39 SMITHE STREET (PRELIMINARY APPLICATION)
DE417276 - ZONE CD-1(519)

DEVELOPMENT PERMIT STAFF COMMITTEE MEMBERS

DEVELOPMENT PERMIT STAFF COMMITTEE RECOMMENDATION: APPROVE IN PRINCIPLE

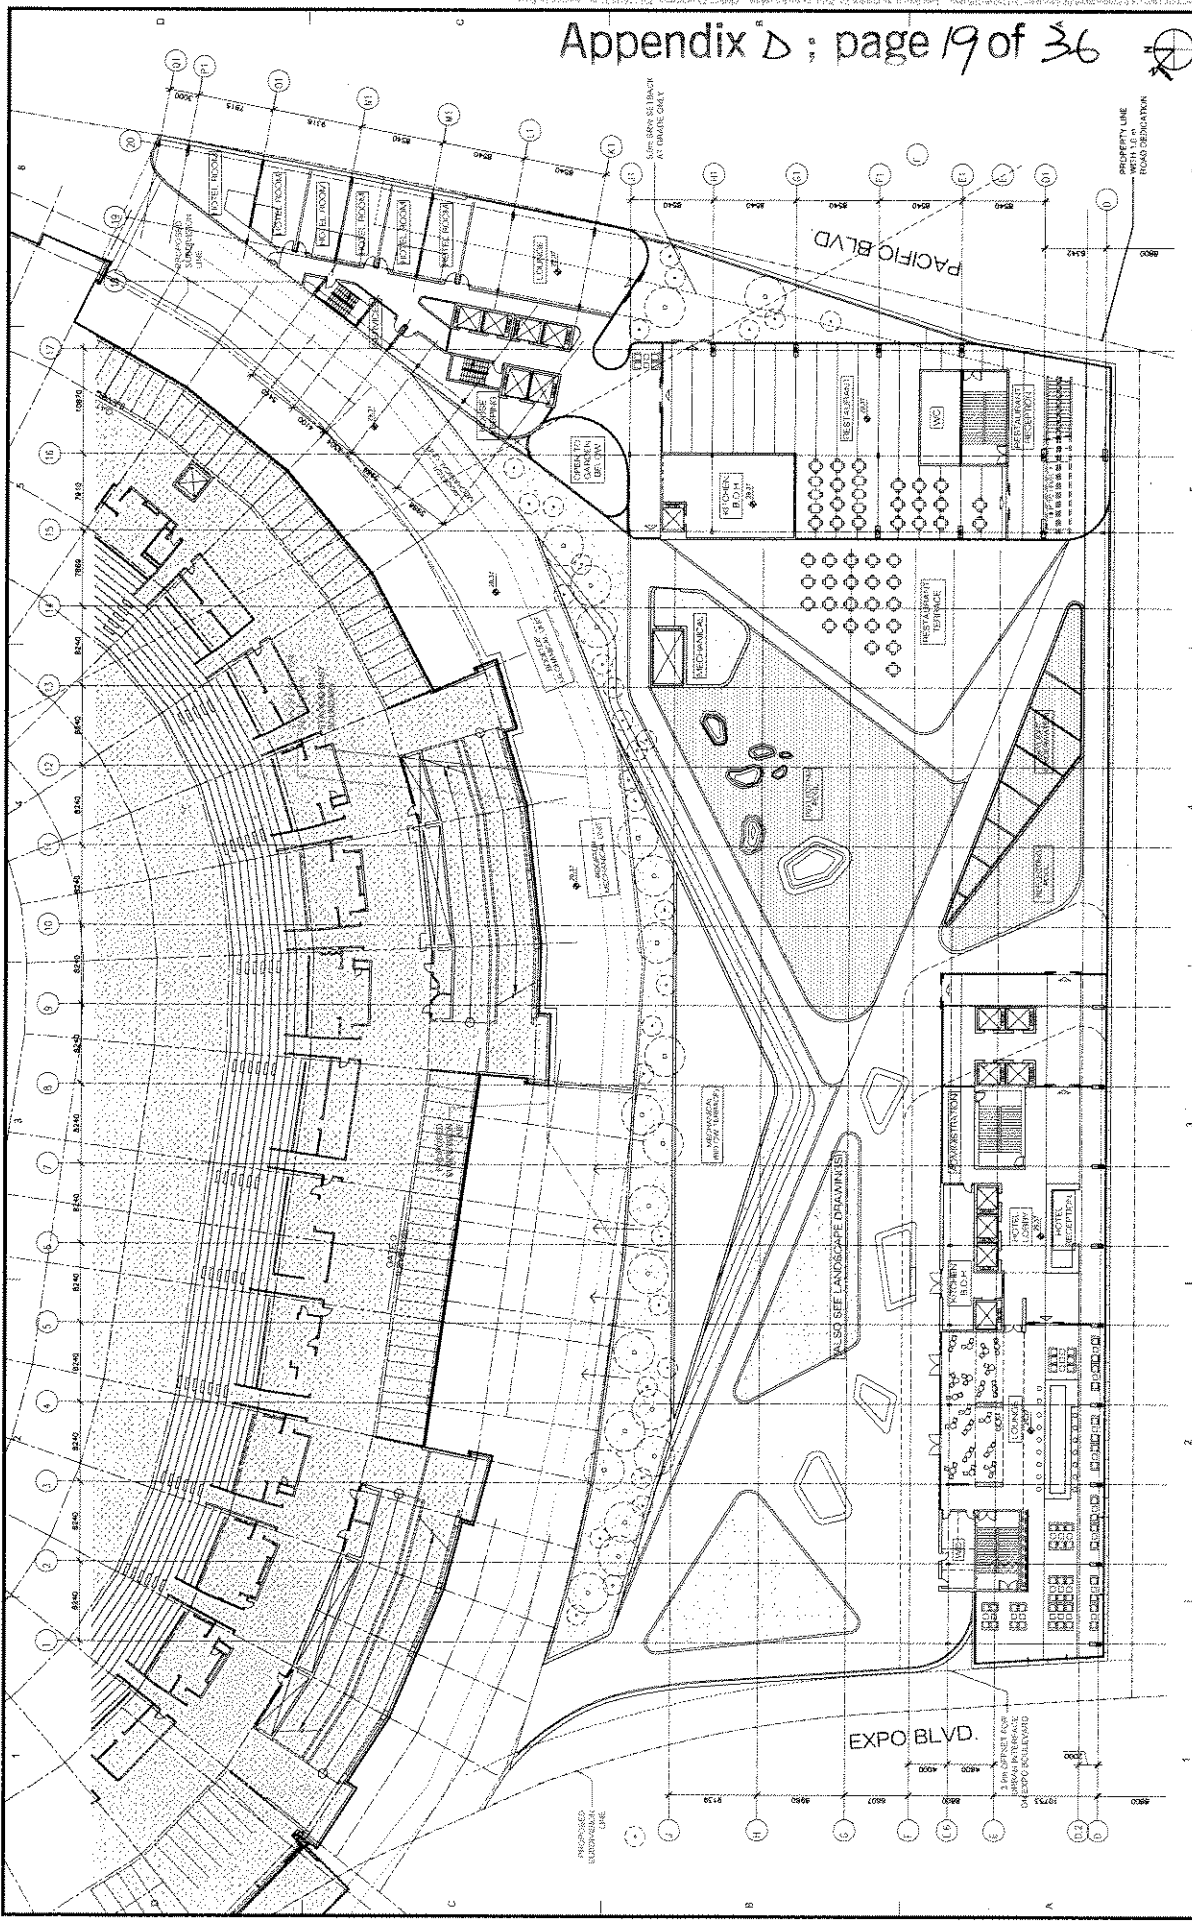
- i. references to "Lounge" on Level 03, Sheet No. A1-03 and Level 06, Sheet No. A1-06 and "Bar" on Levels 02 and 06, Sheet No. A1-02 and Drawing No. L01.03; and

SCALE:
1:250
DWG. NO.:
L01.01

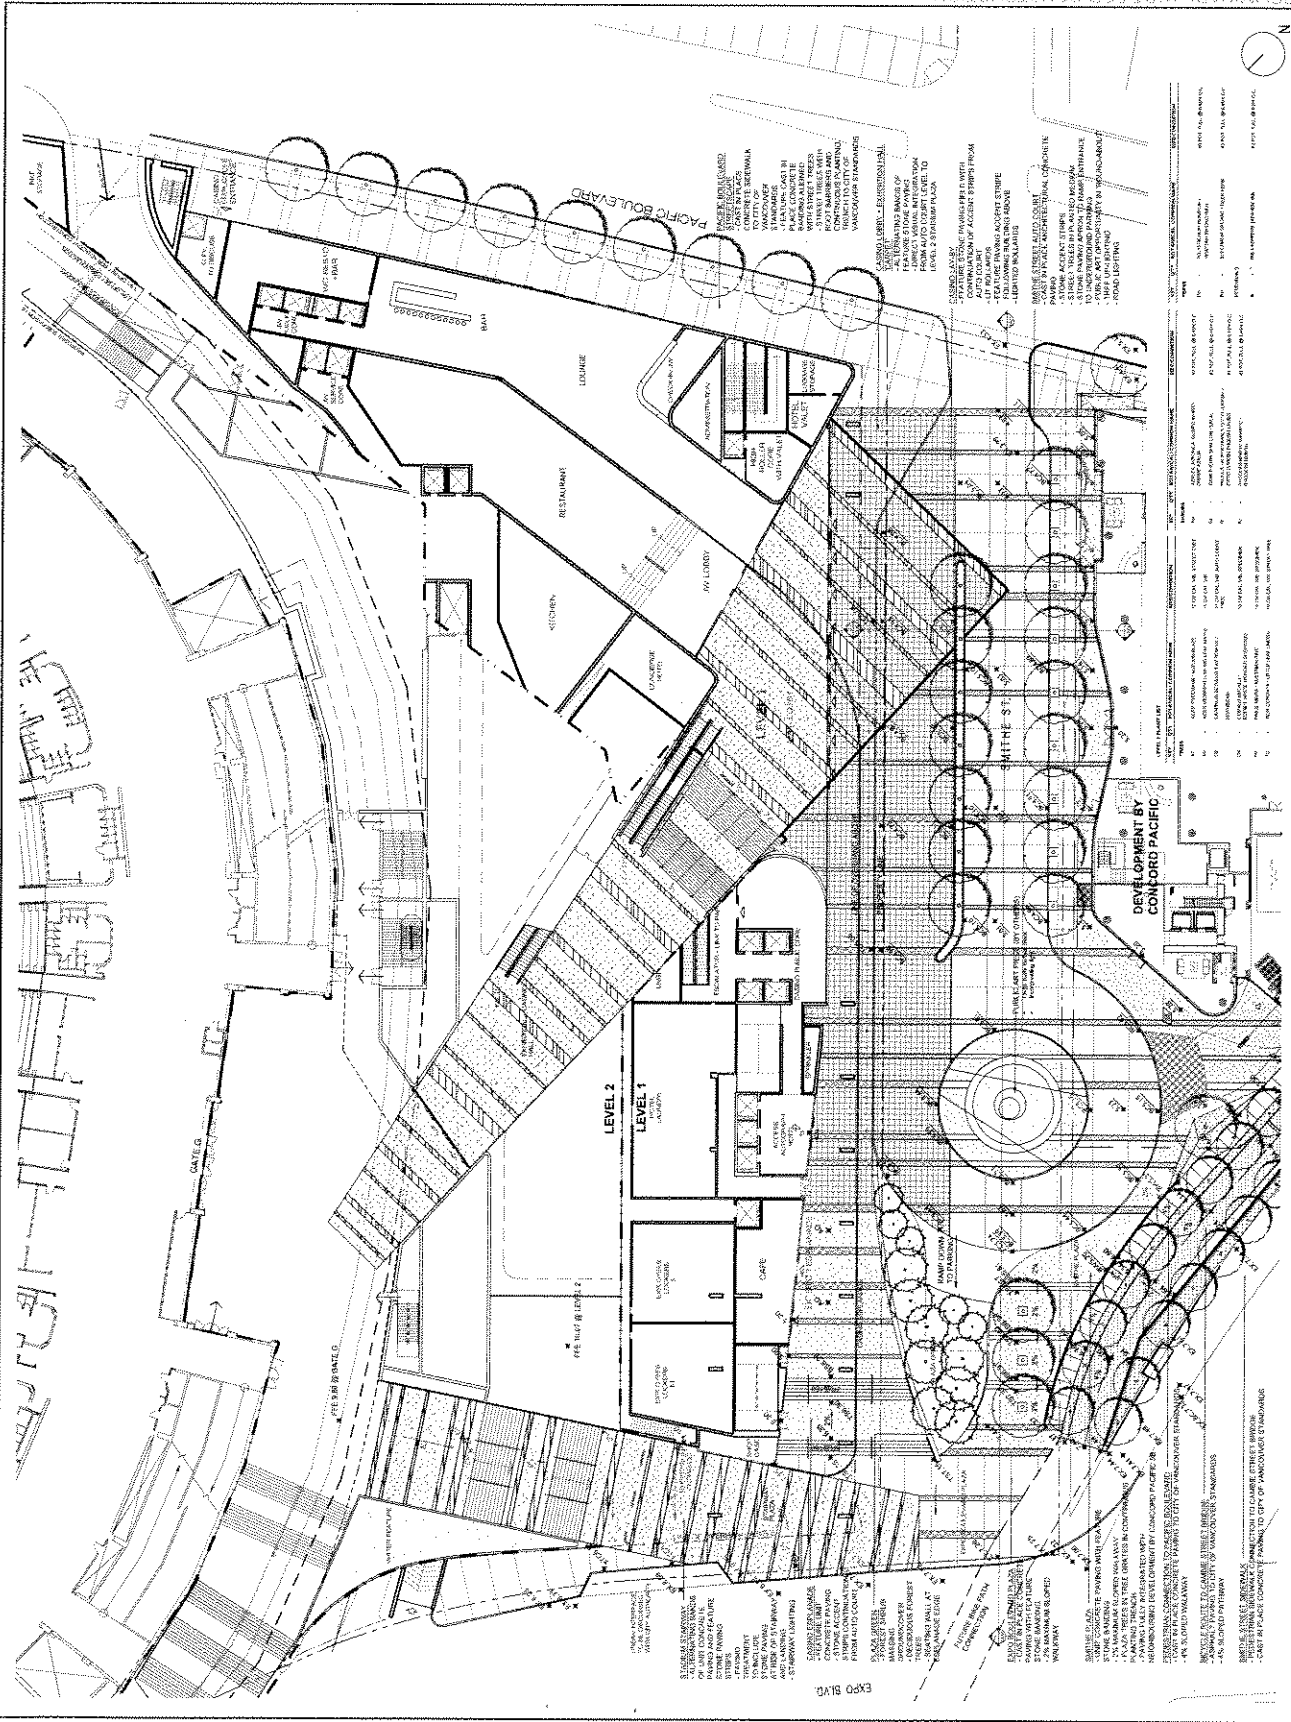
- A.1.33 provision of a notation on Landscape Plan page Lo1.01, "All public realm details to the approval of the COV General Manager of Engineering";
-

DRAWING TITLE:
 LANDSCAPE LAYOUT PLAN
 LEVELS 2 & 4

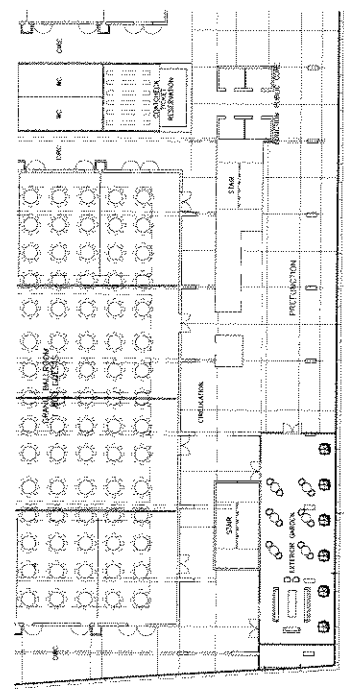
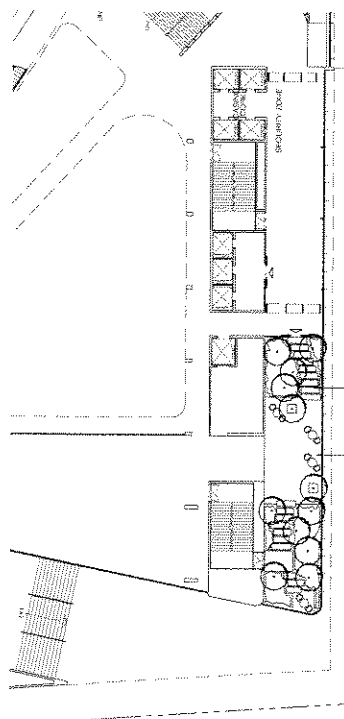
- A.1.26 provision of larger, more detailed Planting Plans for Exterior Terrace Level 2 and Exterior Garden Level 4 on page L01.02, and the Level 15 Pool Deck planter on Page L01.04;

SECTION 'A'
SCALE: 1:250

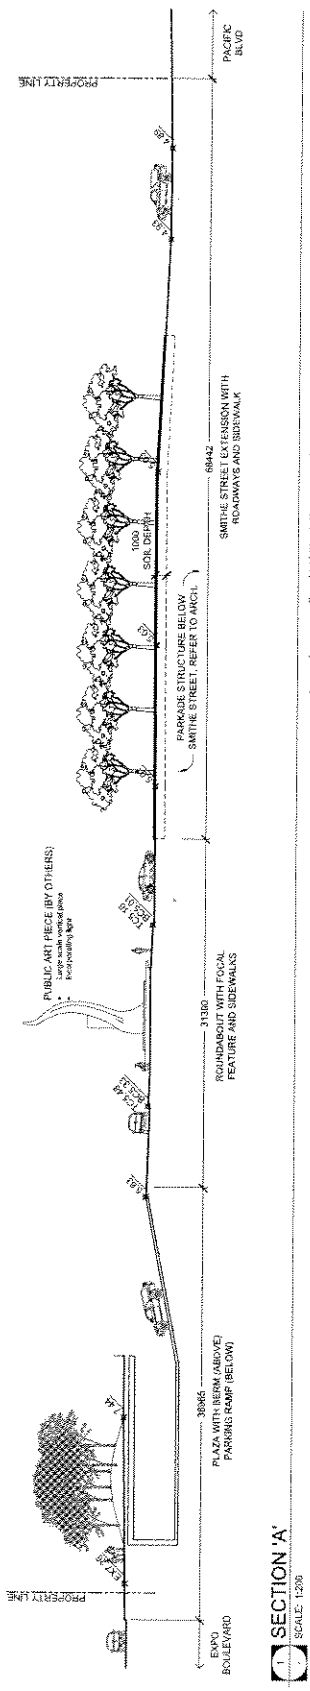
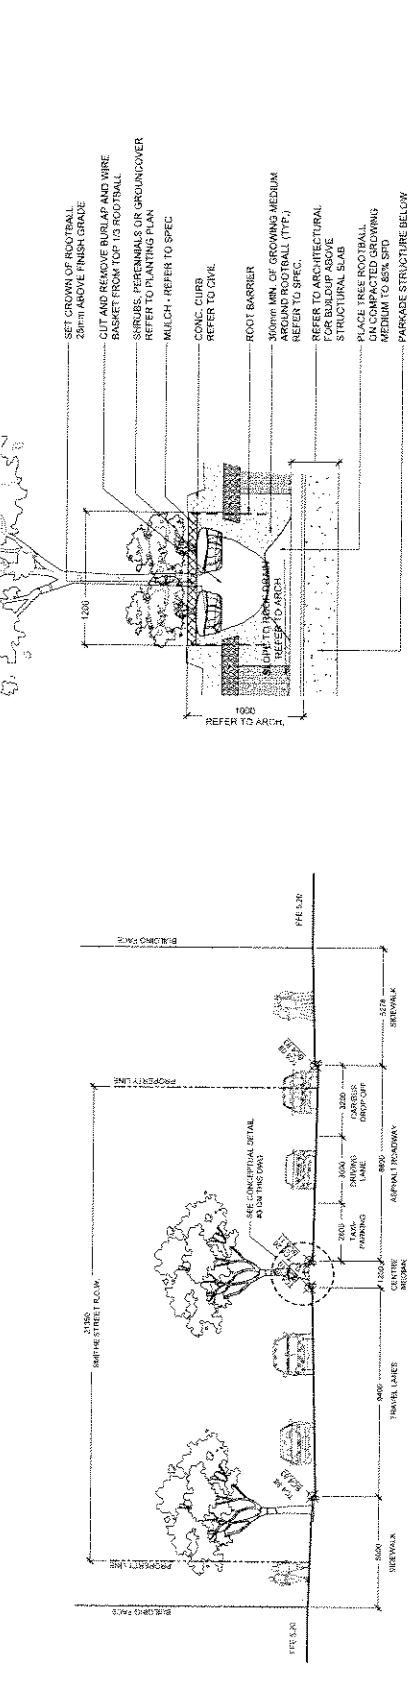
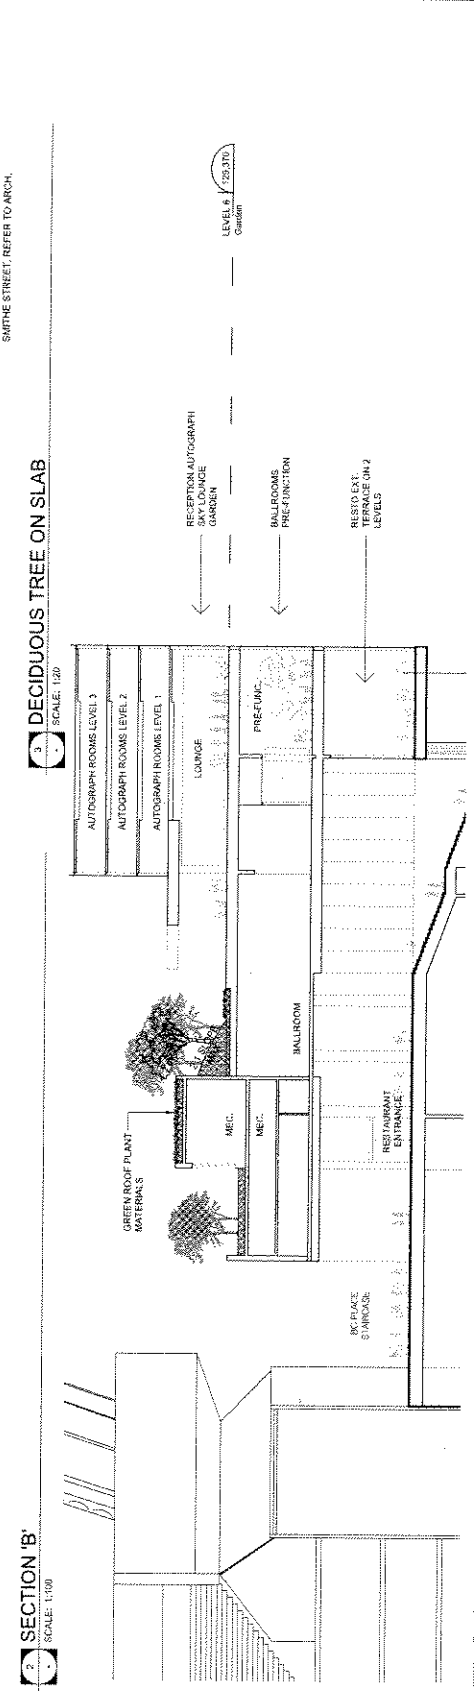
This condition has not been met. The location of the underground parkade roof should be illustrated on the Landscape Sections, in order to determine if enough soil depth has been created for the tree and shrub planting. See Standard Condition A1.25.
